UNITED STATES PATENT AND TRADEMARK OFFICE

10/565,705

Office Action Summary	Application No. 10/565,705	Applicant(s) WEIST, MARIO	
	Examiner DONNELL LONG	Art Unit 3754

DETAILED ACTION

FIG. 12

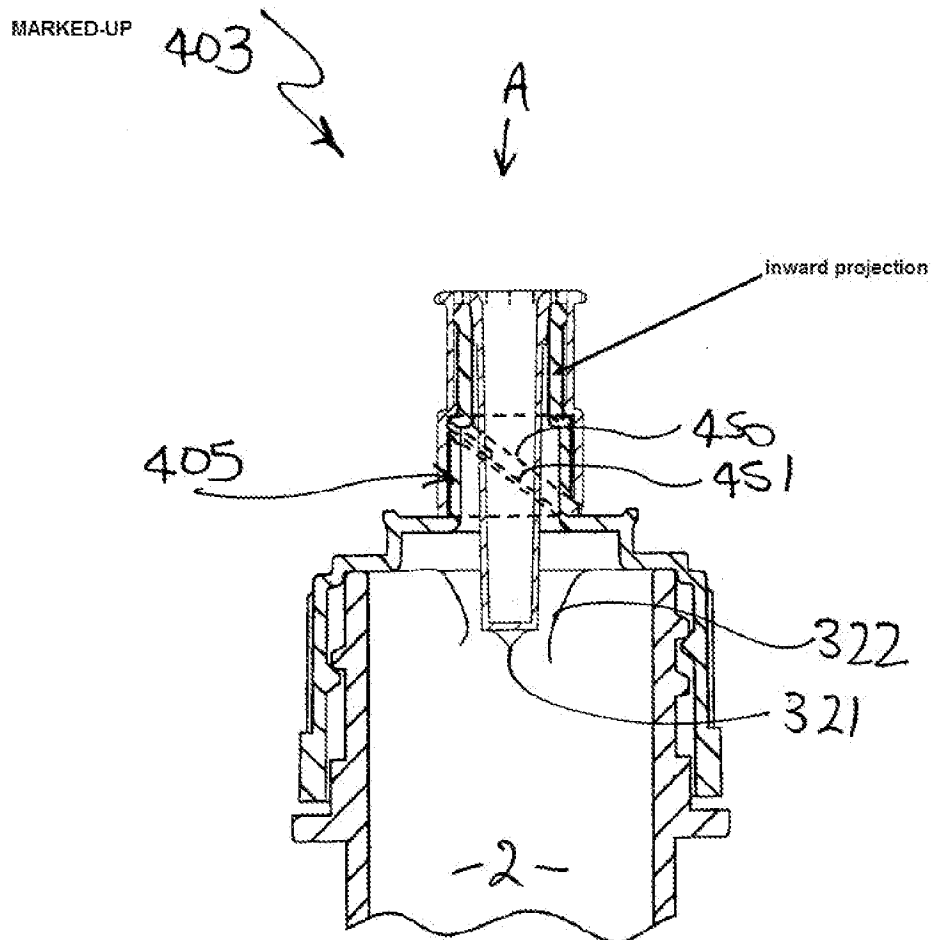
Regarding claim 16, the closure further comprises a projection (marked up FIG. 12) projecting inwardly at an upper end of the connector and a continuous running step

(125) on a lower region on an outer side of the pierce-cutter, sealing the mouth (pg. 10, lines 13-18).

Regarding claim 27, the closure further comprises a projection (marked up FIG. 12 of Coory) projecting inwardly at an upper end of the connector and a continuous running step (125) on a lower region on an outer side of the pierce-cutter, sealing the mouth (pg. 10, lines 13-18).

FIG. 11.

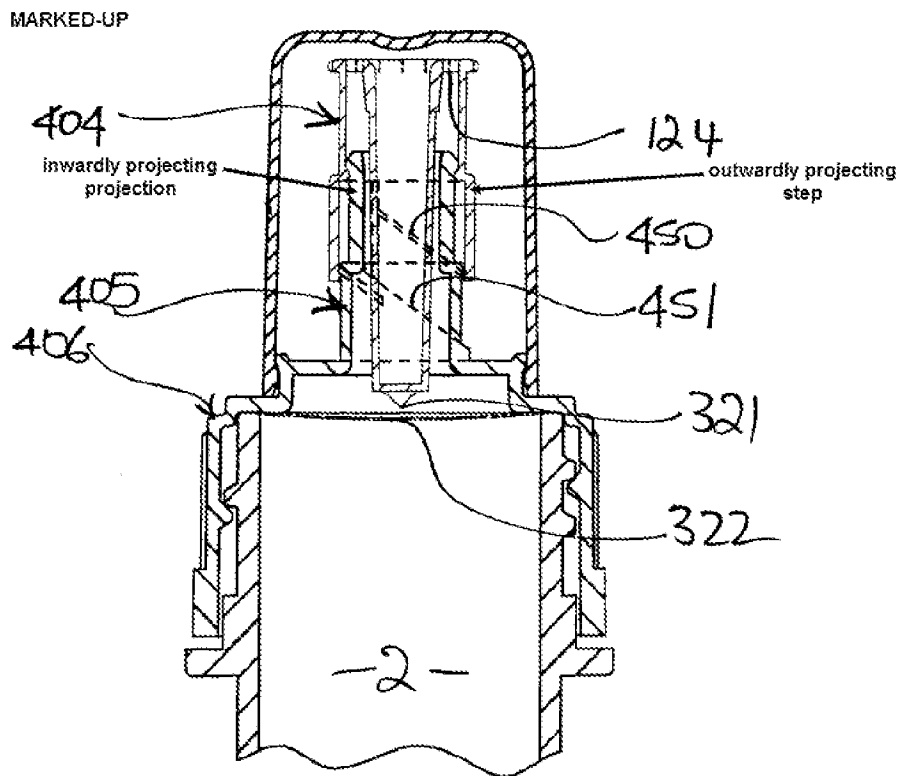
Regarding claim 18, the pierce-cutter includes an outwardly projecting step (marked up FIG. 11), the end connector includes an inwardly projecting projection and the mouth includes an outer rim being round in cross-section and projecting radially

beyond the upper portion of the sleeve, so that when said mouth is pulled upwardly, the outwardly projecting step on said pierce-cutter encounters a stop (108) at the inwardly projecting projection on the end connector with the pierce point of the pierce-cutter being positioned above the bottom of the end connector.

Regarding claim 29, the pierce-cutter includes an outwardly projecting step (marked up FIG. 11 of Coory), the end connector includes an inwardly projecting projection and the mouth includes an outer rim being round in cross-section and projecting radially beyond the upper portion of the sleeve, so that when said mouth is pulled upwardly, the outwardly projecting step on said pierce-cutter encounters a stop (108) at the inwardly projecting projection on the end connector with the pierce point of the pierce-cutter being positioned above the bottom of the end connector.
